Objections submitted in response to East Pye Solar

PINS Reference: EN0110014

Site 1 - Great Moulton:

Assessing the Full Extent of the 1A–1D Development Footprint

DRAINAGE / ATTENUATION

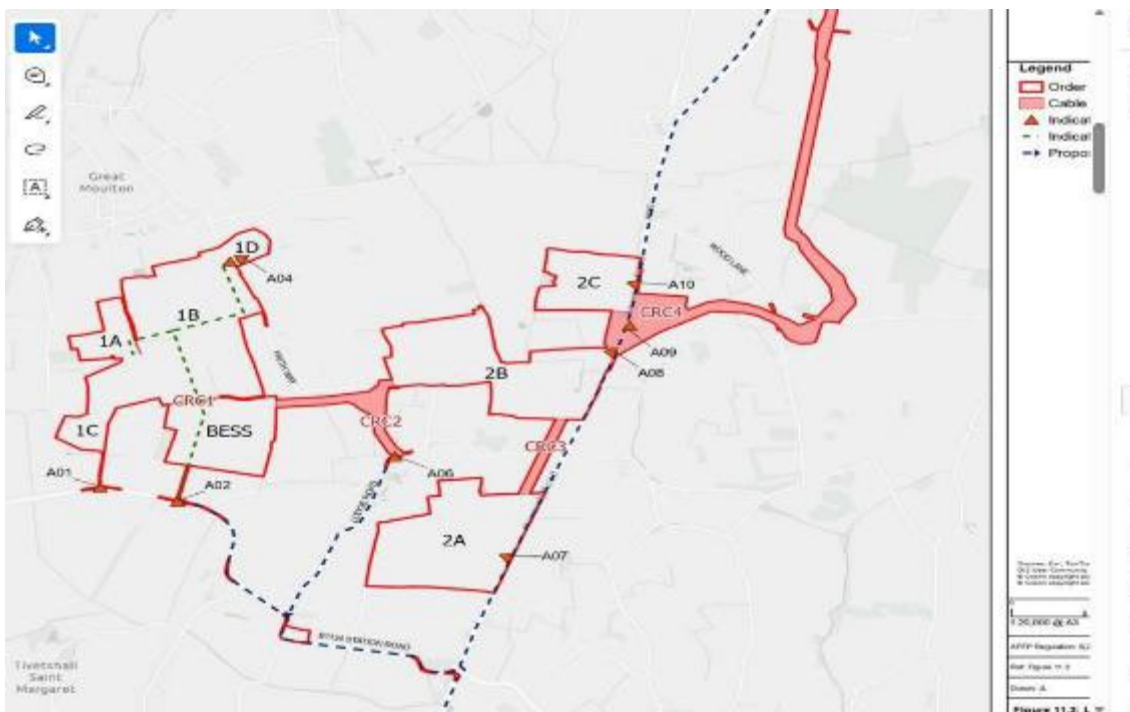
Drainage design should identify clean and contaminated water systems, firewater isolation, penstock failure scenarios, testing, tankering, discharge limits and emergency exceedance routing.

- National Grid Substation drainage is proposed to be lined with an impermeable membrane with controlled discharge.
- Indicative attenuation volume is 7,308-9,246m³, refined to 8,256m³.
- 400kV Project Substation in Sub-Site 1B has revised attenuation of 1,511m³.
- Localised surface-water flood risk around the National Grid Substation and 400kV Project Substation is acknowledged, with a detailed-design solution deferred.

Figure 1- Lden Road traffic noise levels from Extrium

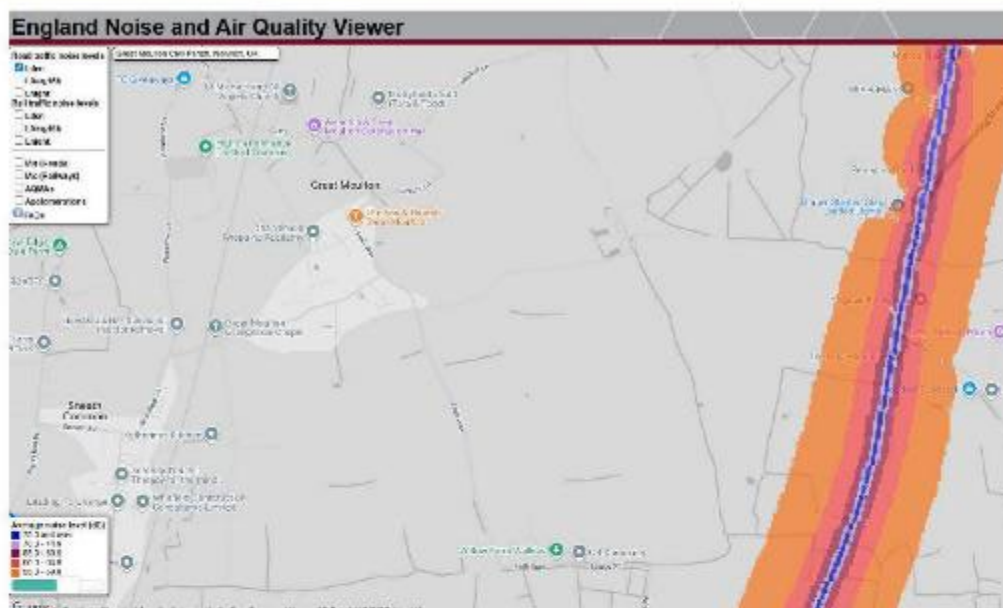
The principal concern at this time is not whether the background sound levels reported by the applicant are numerically correct at the monitoring locations. Rather, it is whether those measurements and the acoustic conclusions drawn from them are representative of the nearest and most affected residential receptors.

The submitted assessment relies upon assumptions regarding the residual acoustic environment, including the degree to which existing background sounds like road traffic, would mask operational noise from the BESS, National Grid substation and associated infrastructure. If those assumptions are not representative of the receptor locations, the conclusions of the BS 4142 assessment may be materially affected. This uncertainty could then be further exacerbated by tonal and character assumptions informing the selected Noise Rating level on which judgement is made as to whether or not there are significant impacts.
